Service-Information Motorcycle

Group: 31
Front Fork

August, 1988
31 021 88
(2320)

Improved Fork Seals - R80 and R100 Models - 1985 On

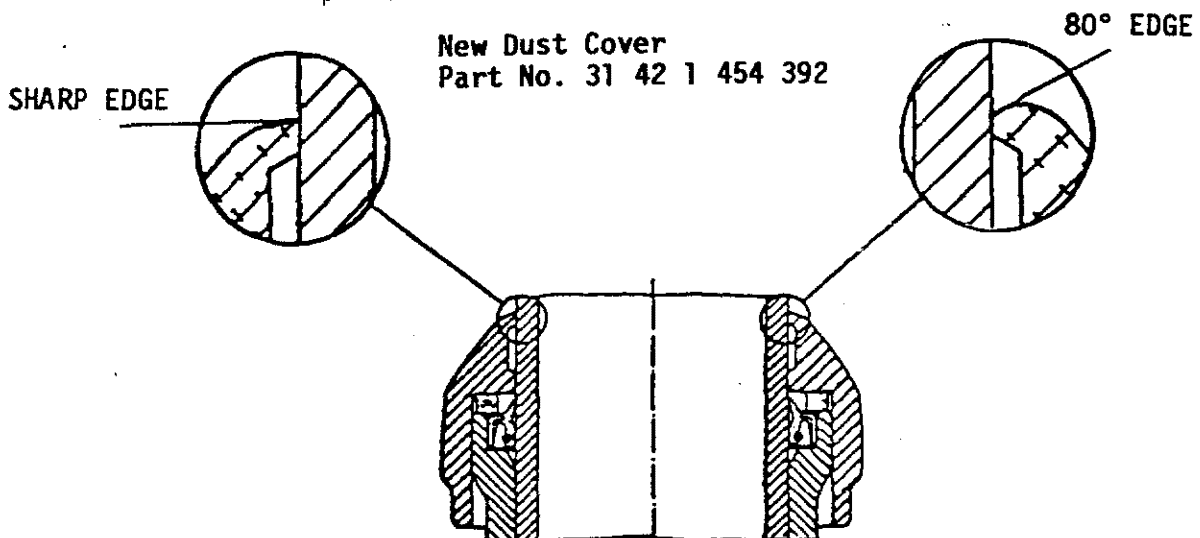
Information: As described in Service Information 31 019 88 (2279) titled: "Improved Fork Seals - K100 and K75 models" the Boxer models are now also produced with a Fork Seal which has an additional dust lip.

In addition to the improved Fork Seal, the new rubber dust covers also have a sharp scraper edge.

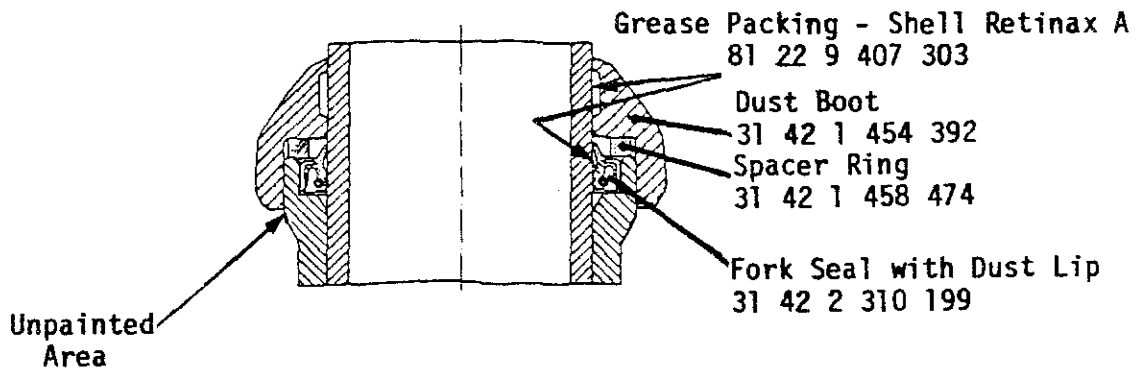
2. An improved, dual-lip Fork Seal with an extra scraper lip is available under:

To ensure that the Fork Seal's scraper lip does not contact the Dust Cover, a Spacer Ring must be placed on top of the Fork Seal.

Part No. 31 42 2 310 199

Part No. 31 42 1 458 474
